# **CITY PLANNING COMMISSION AGENDA**

**THURSDAY, JULY 16, 2015  
8:30 A.M.**

## CITY PLANNING COMMISSION MEETING AGENDA THURSDAY, JULY 16, 2015

FIGURE 1

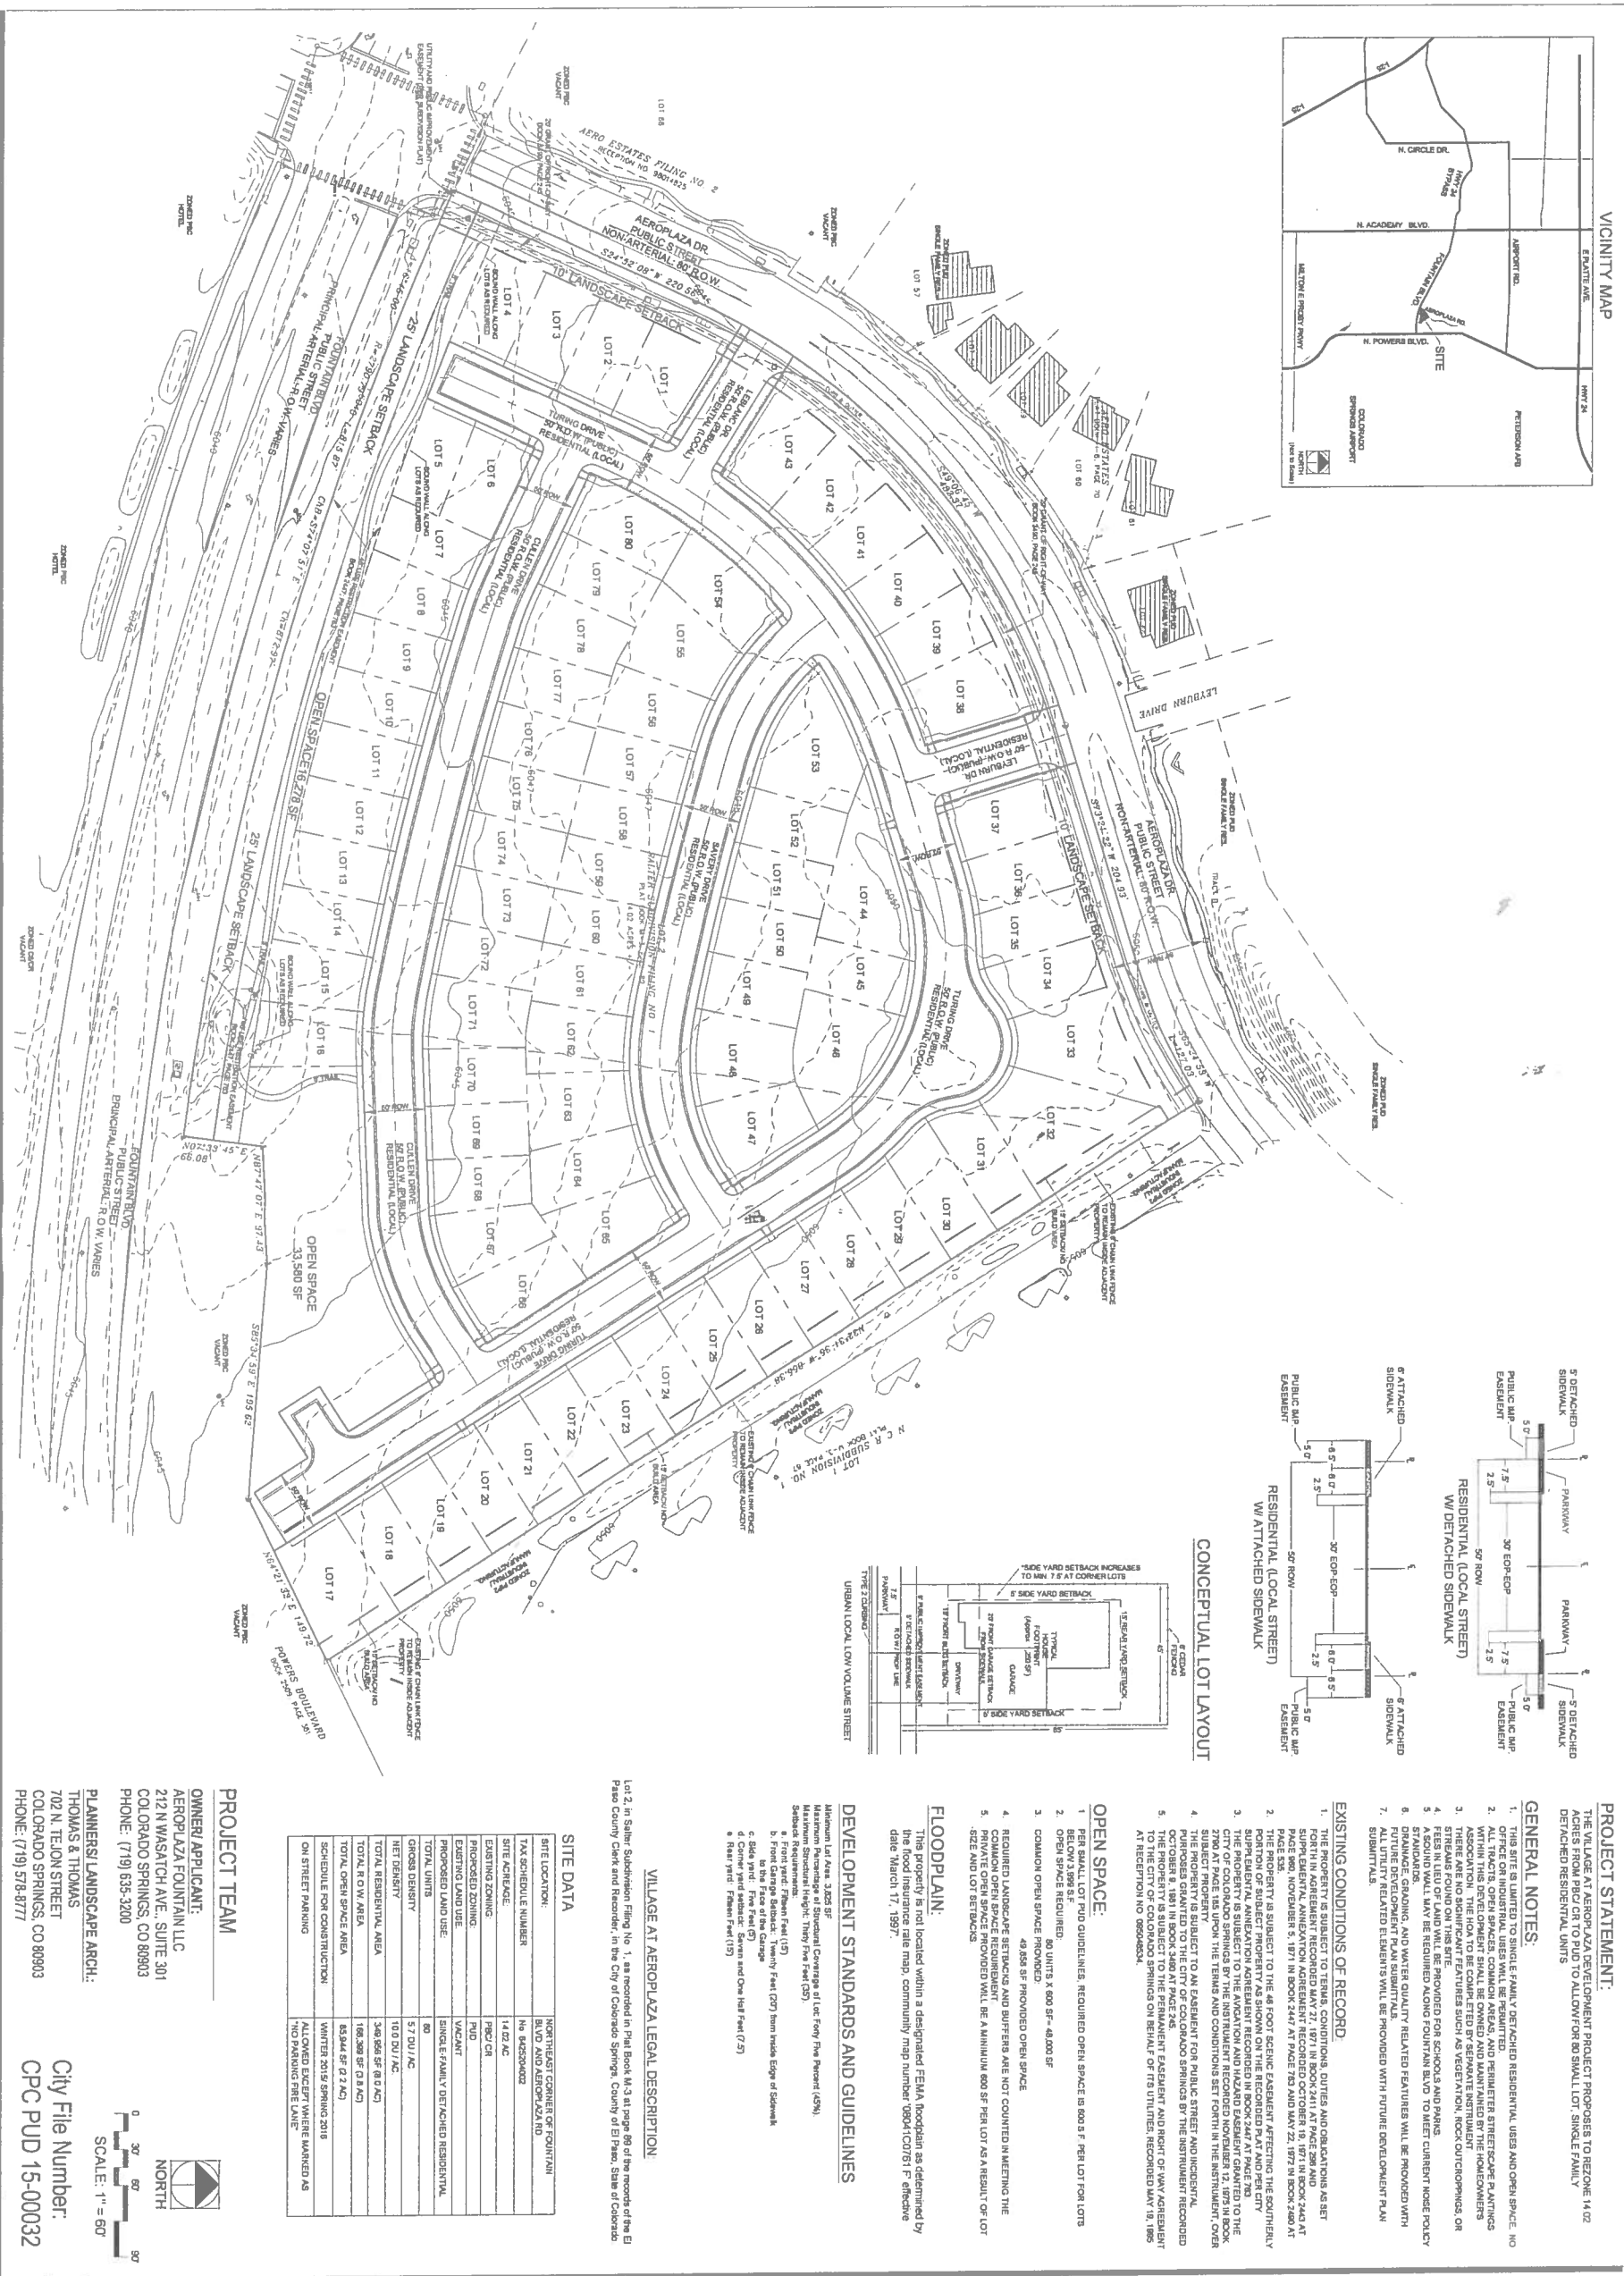
Staff has reviewed the proposed zone change and concept plan and finds that the proposal is not consistent with the review criteria and does not recommend approval of the zone change or concept plan.

The concept plan defines this area as an employment center. Residential with a density of less than 8 dwelling units per acre is not anticipated as part of an employment center; the proposed

project has a density of 5.9 dwelling units per acre. Staff finds that the development is not in conformance with the comprehensive plan.

**Deny** the zone change for Village at Aeroplaza, based upon the finding that the zone change does not comply with the review criteria in City Code Section 7.3.603

**Deny** the concept plan for Village at Aeroplaza, based upon the finding that the concept plan does not comply with the review criteria in City Code Section 7.3.605

FIGURE 1

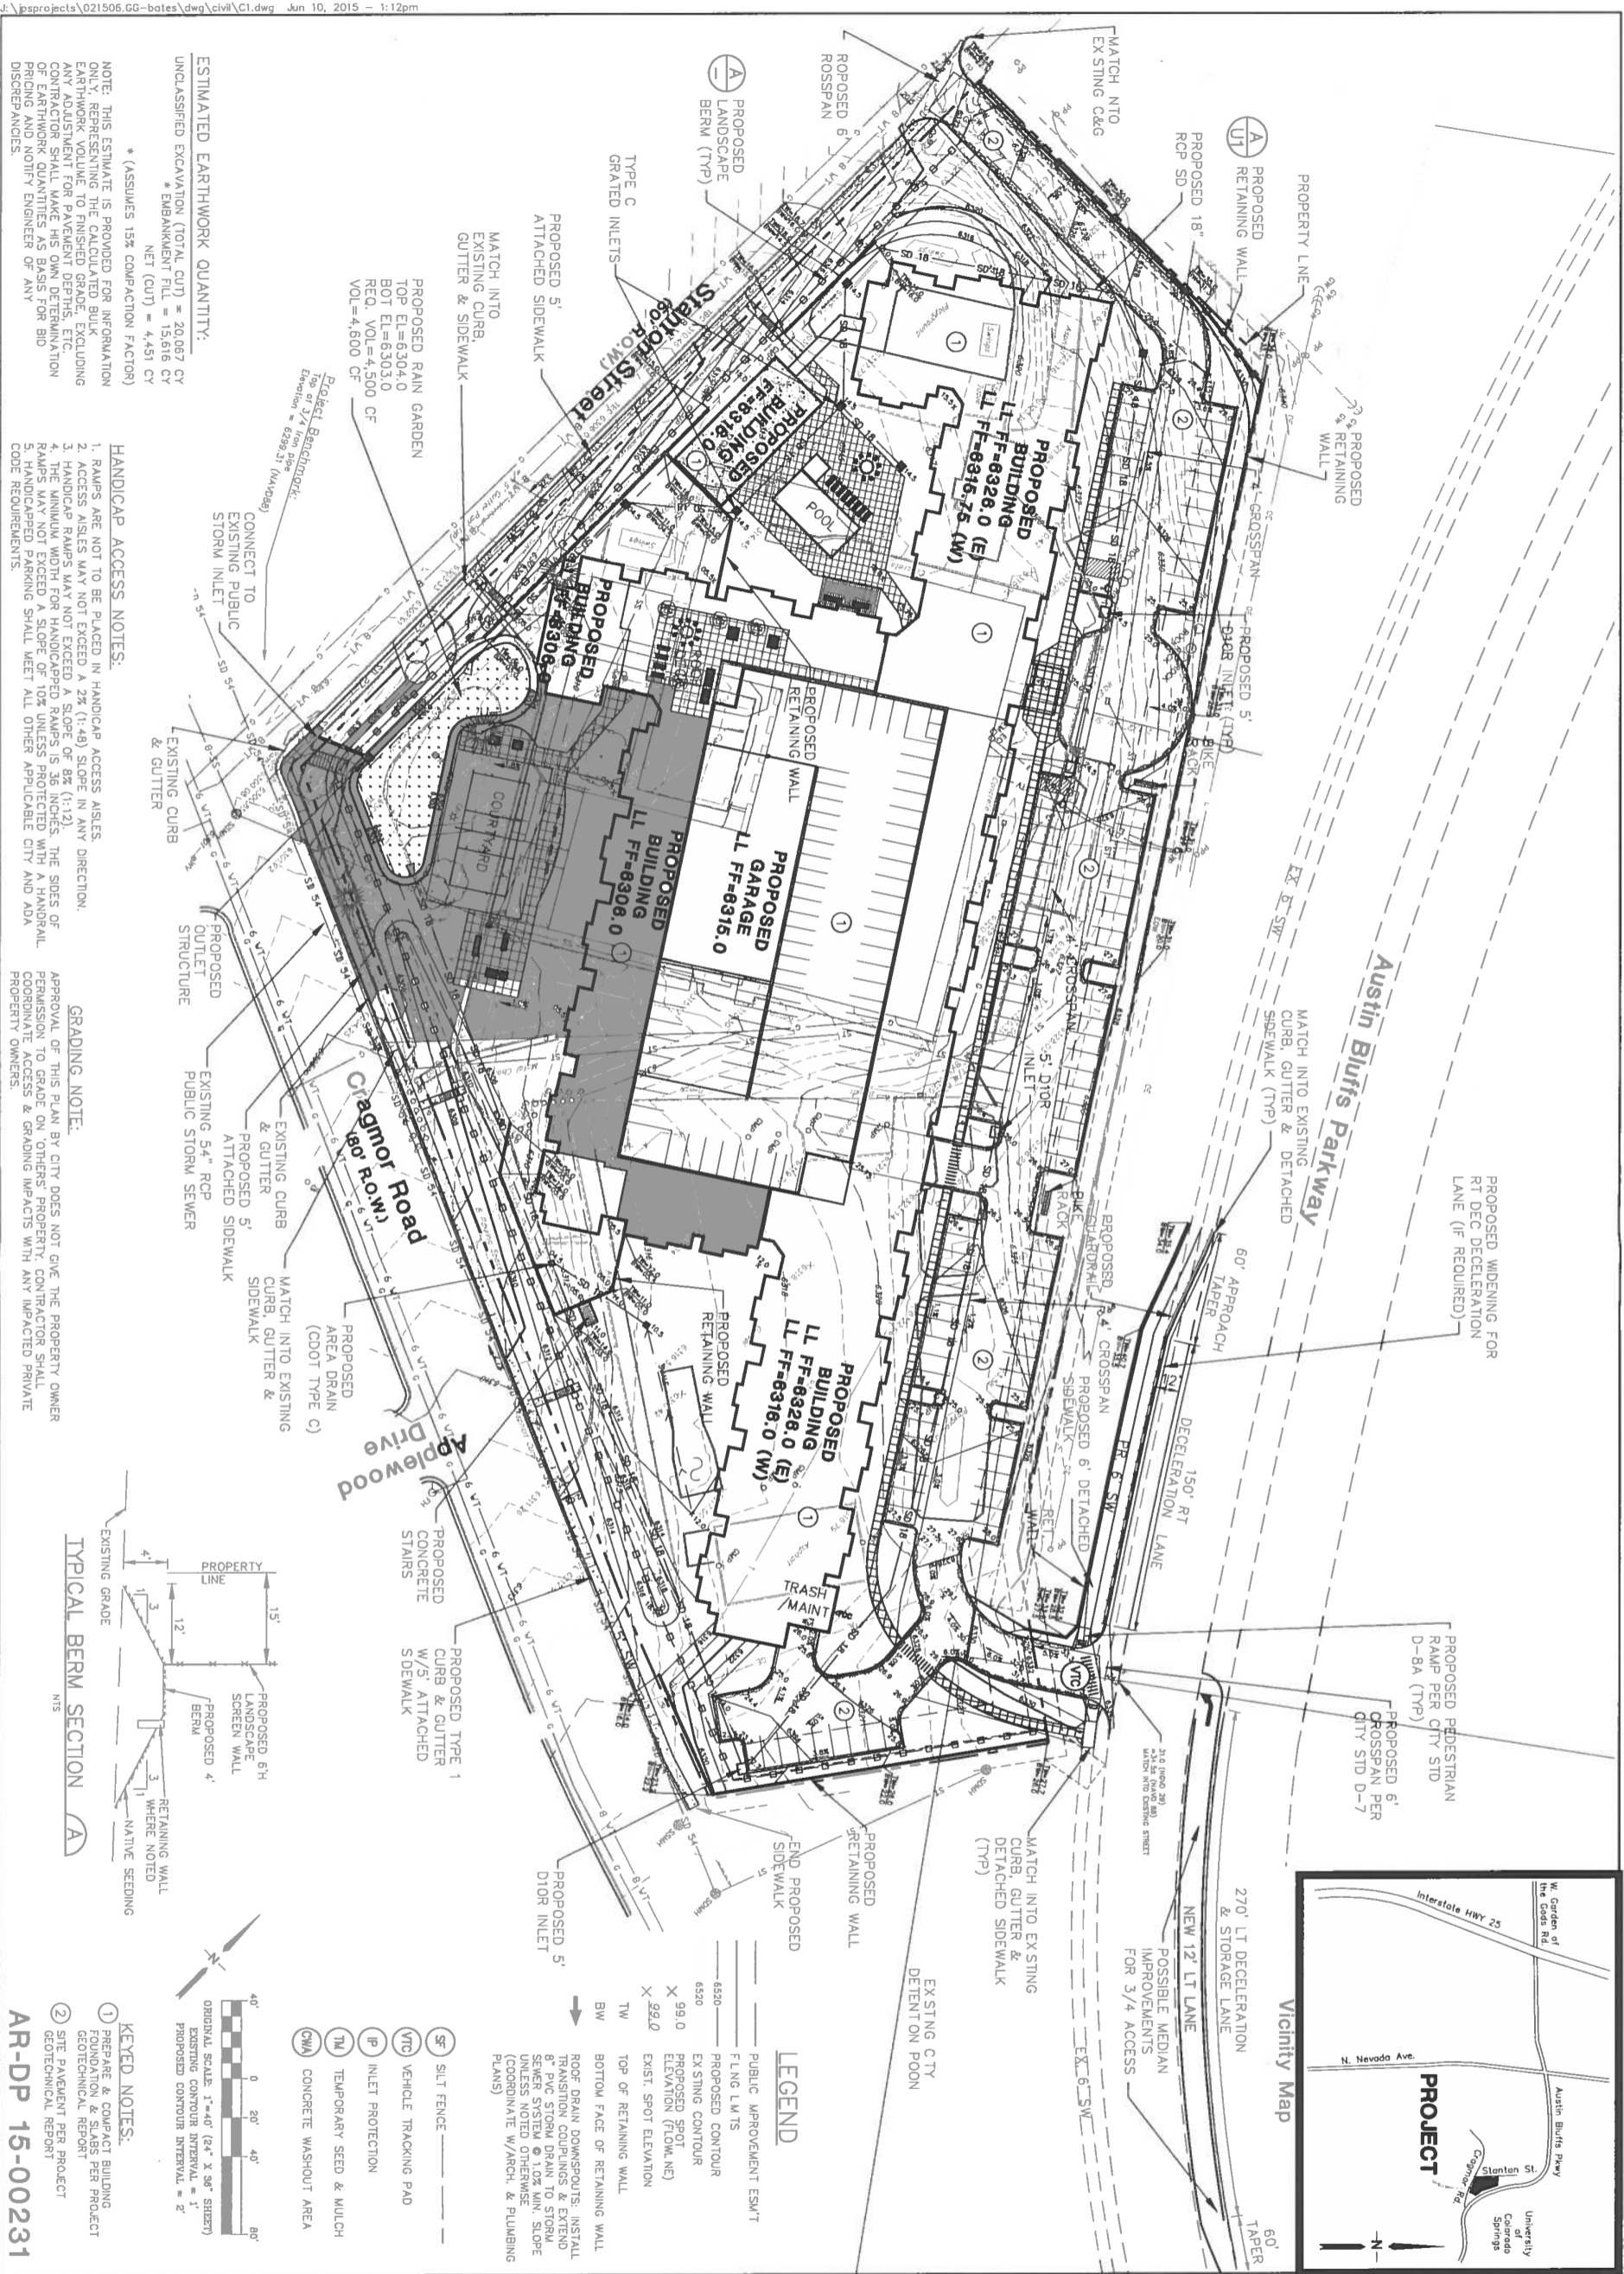
1. Call out the lumen light levels on the photometric plan.
2. Change total provided under the parking requirement section to total required.
3. Correct the 'Required' Tree Count for Cragmoor to 29 (not 39).
4. Correct the 'Required' Tree Count for Stanton to 25 (not 33).
5. Correct the Internal tree calculation to reflect 350 shrub substitutes (not 270).

**Approve** the development plan for Bates Student Housing, based upon the finding that the development plan complies with the review criteria in City Code Section 7.5.502.E, subject to compliance with the following conditions of approval and technical plan modifications:
